Notice of Allowability

10/525,074

The title of the invention has been changed to: "Antenna-coupled microbolometer including detection of a change in electrical resistivity of a locally doped region".

FIG. 1

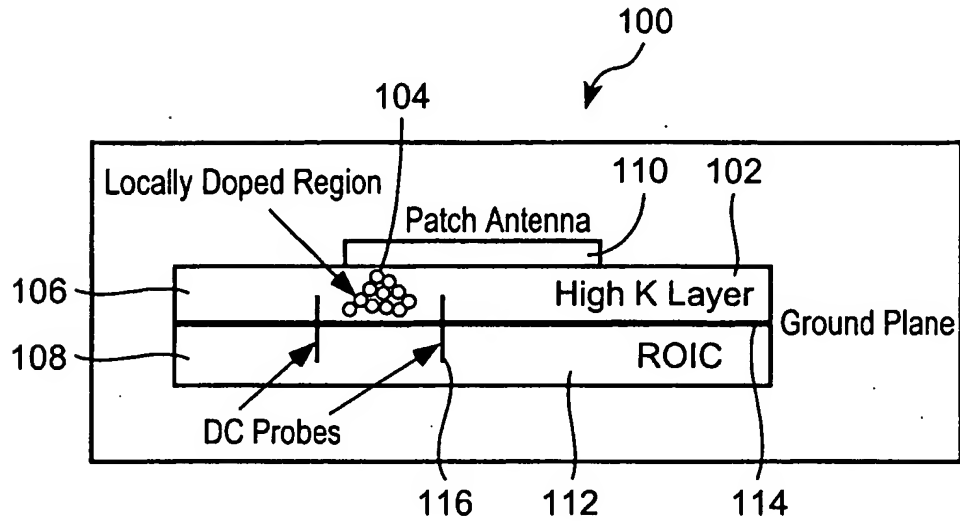
In the drawing: The label of "FIG. 1" has been changed to "THE FIGURE" (See attachment).

THE FIGURE
